Response to Submissions

Smeaton Grange Waste Recycling and Transfer Facility

52 Anderson Road, Smeaton Grange | SSD7424

Prepared for Benedict Recycling Pty Ltd
January 2017

drawing title
ROOF PLAN

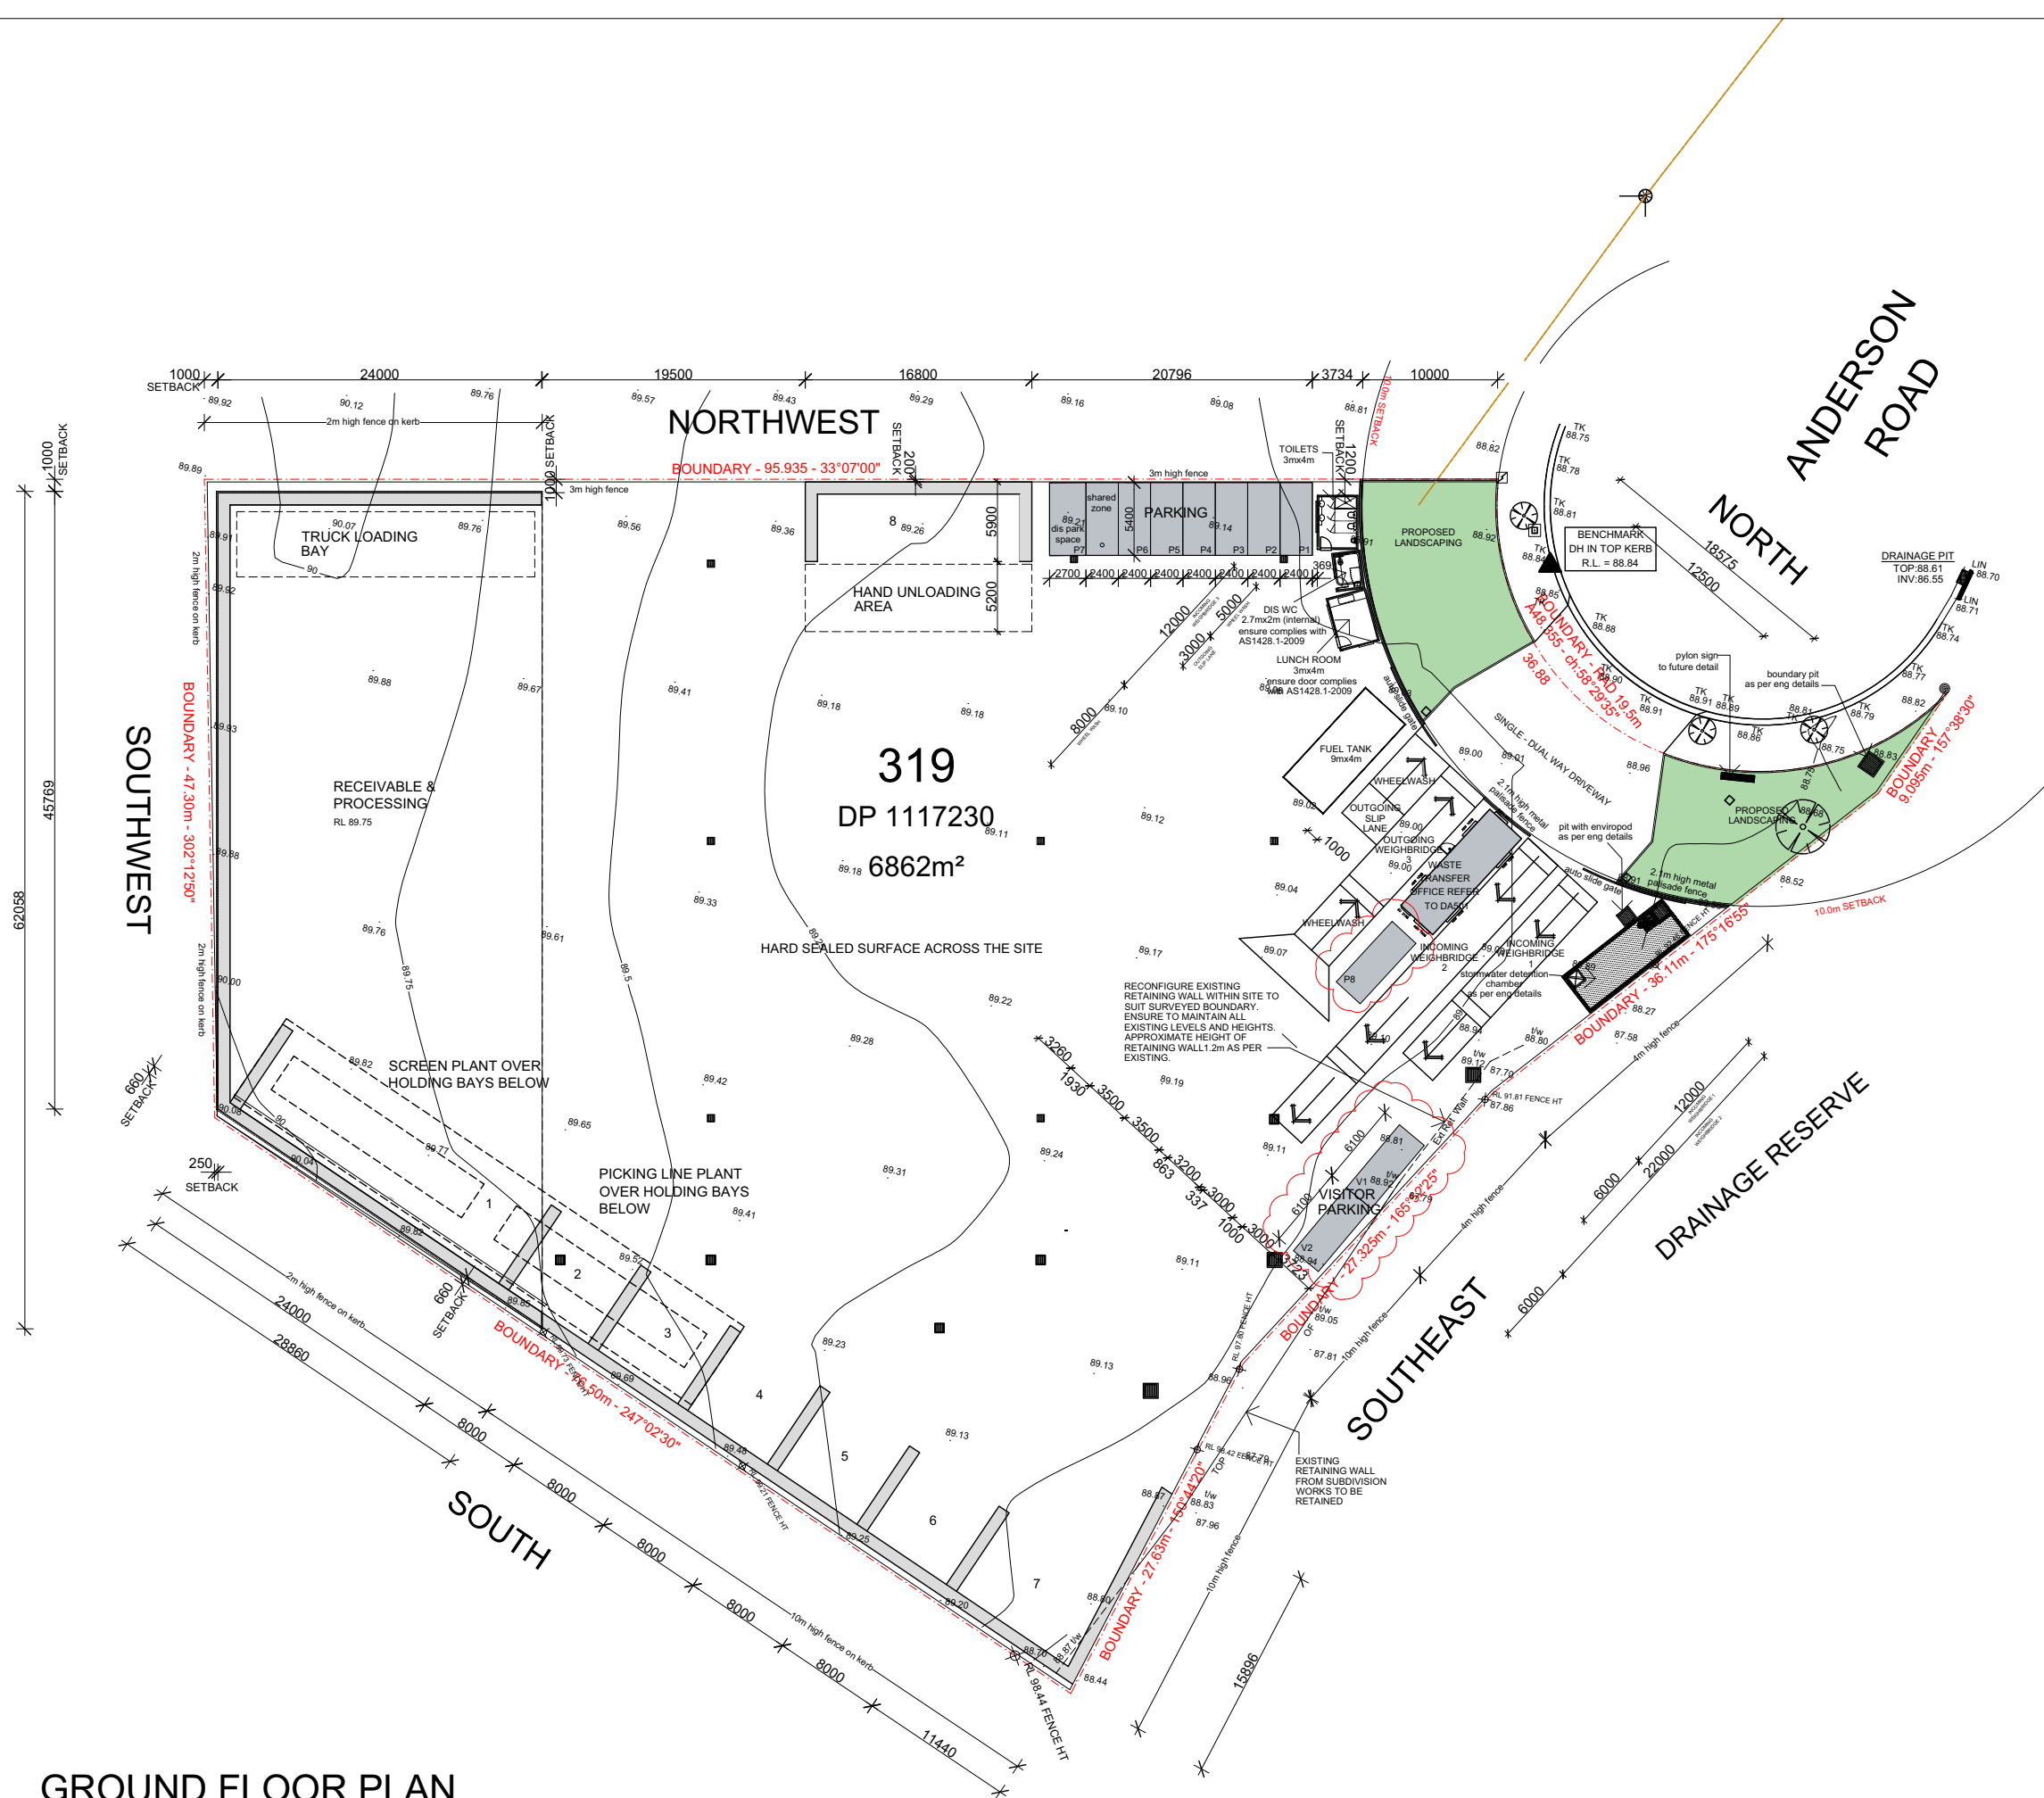
Architectural plans – it is not clear if the proposed development fully complies with the 11 m maximum building height development standard that applies to the site

Revised site plans (Revision E, 18 August 2016) are provided in Appendix C. These plans provide all levels. The maximum height of the roof line will be 11 m or less from ground level. This could be specifically conditioned to give all stakeholders additional assurance that this height limit will not be exceeded.
